**SUNDRY NOTICES AND REPORTS ON WELLS**  
**Do not use this form for proposals to drill or to re-enter an abandoned well. Use Form 3160-3 (APD) for such proposals.**

8. Well Name and No.  
Ute Mountain Tribal 24-43

**PLUG AND ABANDONMENT PROCEDURE  
UTE MOUNTAIN TRIBAL 24-43**

**Conditions of Approval - Notice of Intent to Abandon:**

## Proposed P&A

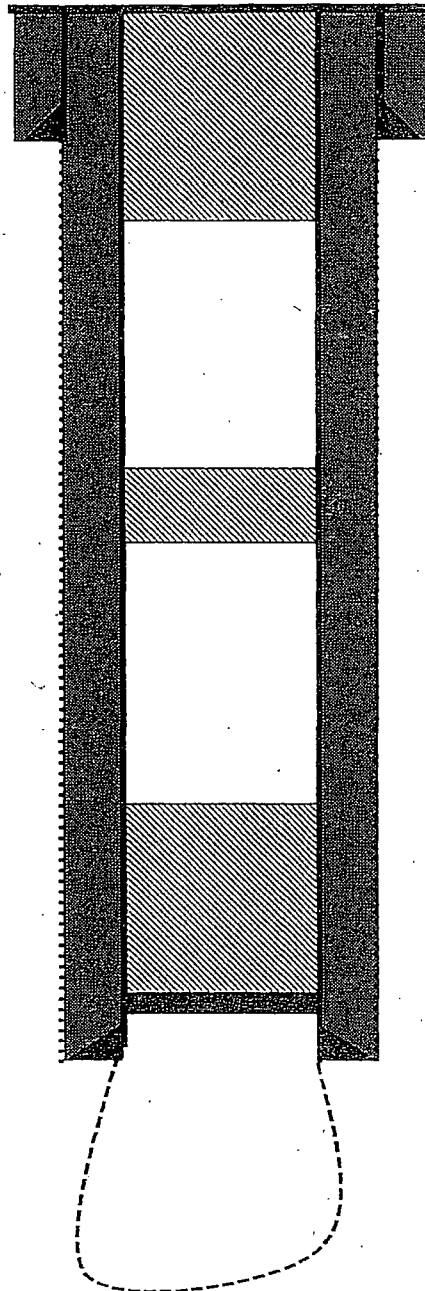
- 6a. Cement plugs placed inside casing shall have sufficient volume to fill a minimum of 100 ft. of the casing or annular void(s) between casings, plus 10% excess volume per 1000 ft. of depth.

- 6b. Surface plugs must be a minimum of 50 ft. within casing and annular voids.
  - 6c. Cement plugs placed to fill an open hole shall have sufficient volume to fill a minimum of 100 ft. of open hole, plus 10% excess volume per 1000 ft. of depth.

- 6d. Tag the Gallup Mesaverde plug.
  - 6e. Tag the Pictured Cliffs plug.
7. The well must be filled with a wellbore mud sufficient to stabilize the wellbore. In the absence of any formation pressure data provided by the operator, this mud will have a minimum weight of **9 ppg**. The mud must be left between all plugs.
